**GARD final combined response to
Gate 1 reports and draft Ofwat decisions
on
Strategic Resource Options**

GARD's revised response to Gate 1 submissions and Ofwat/RAPID's draft decisions

GARD Final Combined Response to Gate 1 Reports and draft Ofwat decisions on Strategic Resource Options

Figure 3 - Recorded effluent outflows from Mogden STW 2013-2016

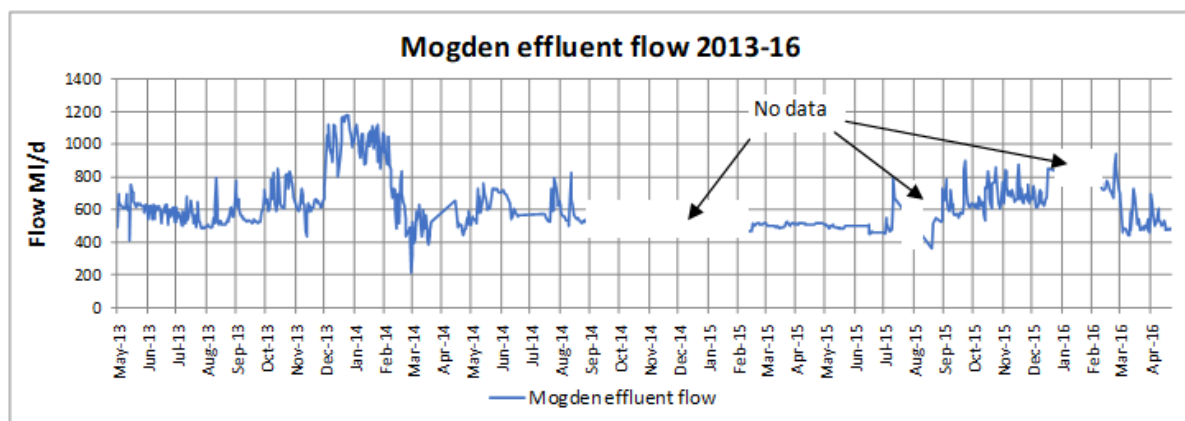
We agree that it is reasonable to consider a 300 MI/d scheme for Beckton reuse. However, we do not agree the limitation of the Mogden reuse options to a maximum of 200 MI/d. The recorded outflows from Mogden STW in 2016 are shown in Figure 3³⁵:

The dry weather flow from Mogden is about 450 MI/d, so larger reuse options should be considered in Gate 2, probably up to 450 MI/d in the case of the Teddington DRA option.

Figure 4 - Impact of 350 MI/d regulation on flows below Vyrnwy dam

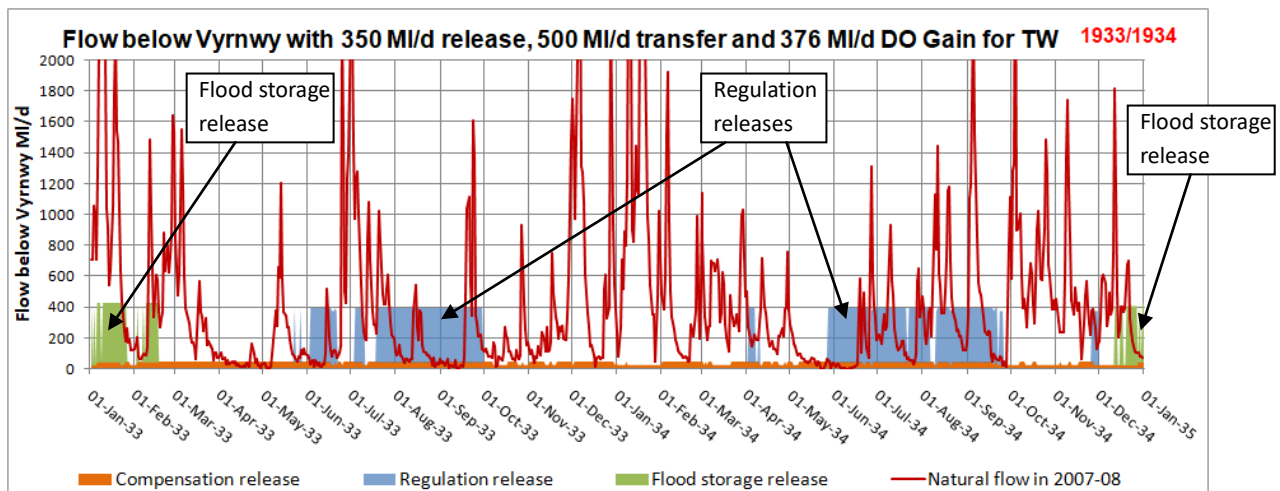
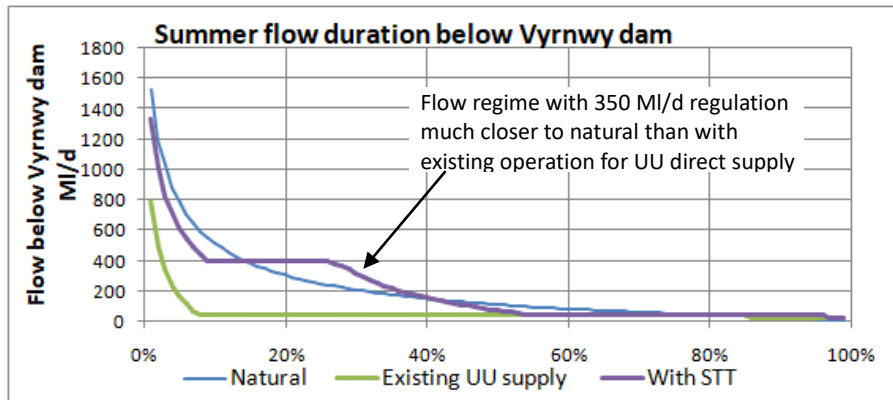
The impact of releasing 350 MI/d on flows below Vyrnwy dam is shown on Figure 4 below, which is taken from modelling of the 350 MI/d regulation scheme proposed by GARD for WRMP19 and described in Appendix C to this report. The upper plot shows flow duration curves for April to September, when most regulation takes place, and the lower plot compares flows in the drought of 1934 with the natural flows in 2007 and 2008, two naturally wet years:

The flow-duration plot shows that the April to September flow regime below Vyrnwy dam would be much closer to natural than at present when flows are continuously at the 25-45 MI/d compensation level. In geomorphological terms, this would be a marked improvement on the existing flow regime. The regulated summer flow of nearly 400 MI/d in a drought like 1934 would be unnaturally high as a continuous flow, but comparable to natural flows in wet summers like 2007 and 2008, albeit lacking the natural variation. At present, Vyrnwy dam flood storage releases of about 400 MI/d are made in most autumns and winters to lower the reservoir water level for flood retention – these releases are approved by NRW and deemed not to adversely affect the fisheries.

Figure A1 - WRMP19 and WRSE historic data periods in the context of global temperature changes since 1880

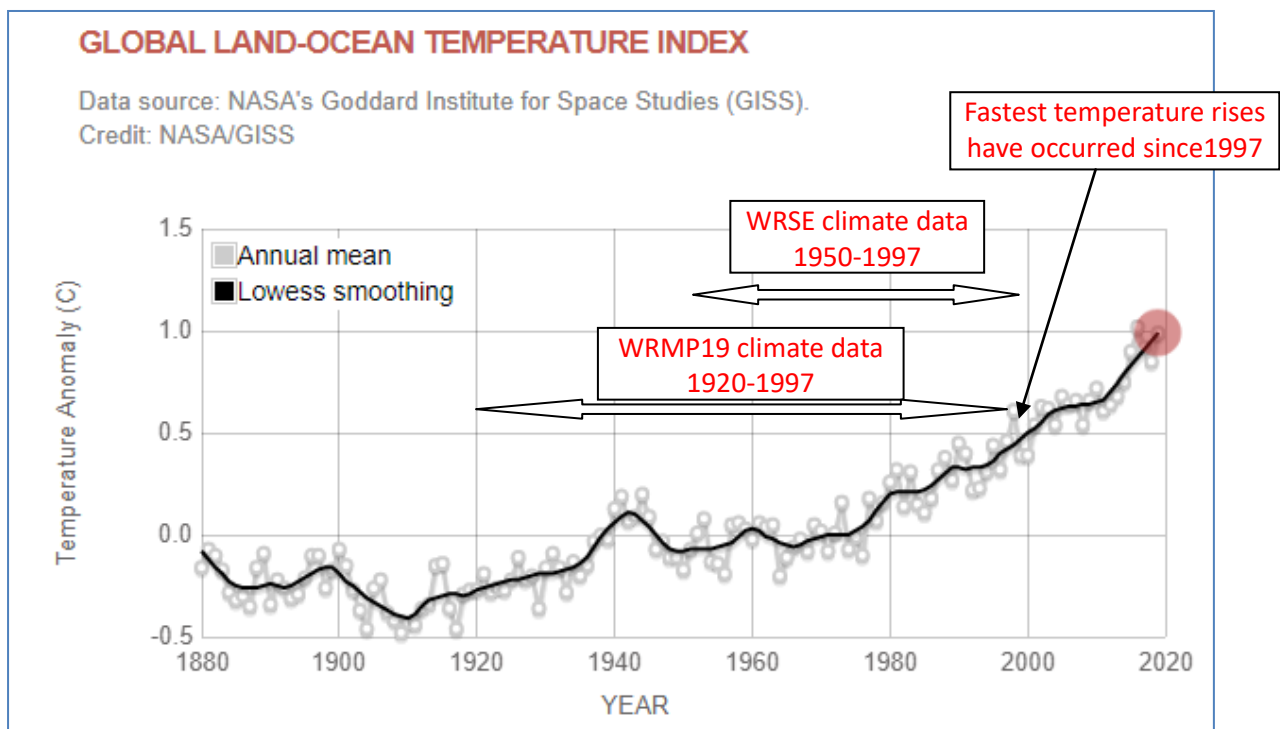
The new stochastic climate data are to be generated from only 48 years of historic records, 1950-1997, compared to the 78 years of records, 1920-1997, which were typically used to generate stochastic data for WRMP19. The reduced length of historic records used in the new analysis has been justified in paragraph 2.5 on the grounds of the use of more climate drivers than previously and better-quality data for the additional climate drivers being available only from 1950. Paragraph 2.10 acknowledges that some water companies may have used historic data up to 2019, but does not explain why data since 1997 are not being used in WRSE's analysis.

Figure A1 shows the periods of climate data used for the WRMP19 and WRSE stochastic data generation, in the context of global temperature changes since 1880⁴², highlighting the rapid changes since 1997:

Therefore, the period 1950-1997 seems an unsatisfactory basis for generating the stochastic data, lacking both the period of extreme low flows pre-1950, with several long duration droughts, and the recent period of most rapid climate change.

Figure A3 - Differences in versions of hydrologically modelled flows on the lower River Test

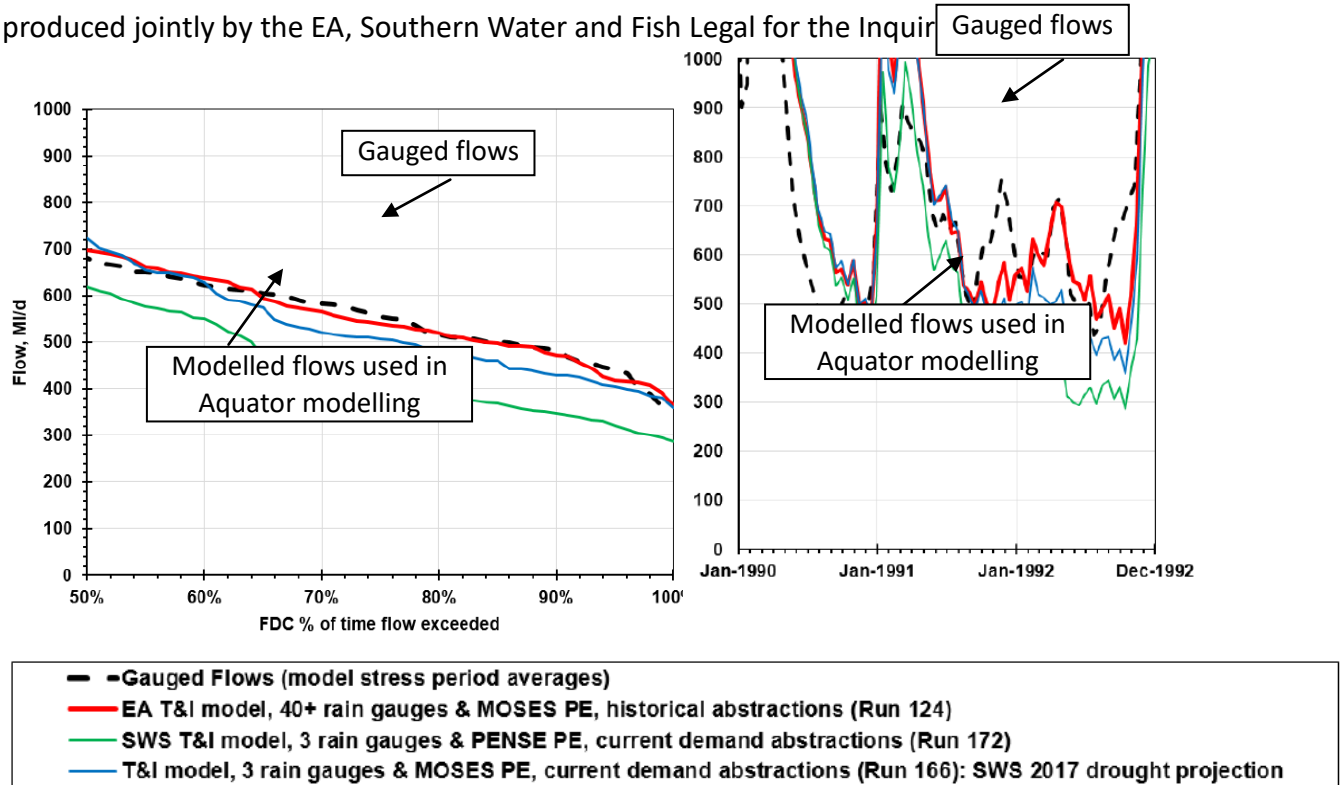
Southern Water’s Aquator modelling used the worst version of the hydrological modelling, the green line shown in Figure A3, for the reasons explained in the SOCG as follows⁴⁸:

Discrepancies of the magnitude shown in Figure A3 (ie. the differences between the green modelled flows and the black dashed gauged flows) would lead to major inaccuracies if they were to occur in flows used in WRSE’s regional system simulator. The difficulties described above will inevitably be experienced in the latest hydrological modelling – ie the absence of climate data covering historic droughts and the computational burden of applying the more accurate modelling techniques over thousands of years of stochastic climate data. These difficulties will be widespread over the south-east region, including the lower River Thames.
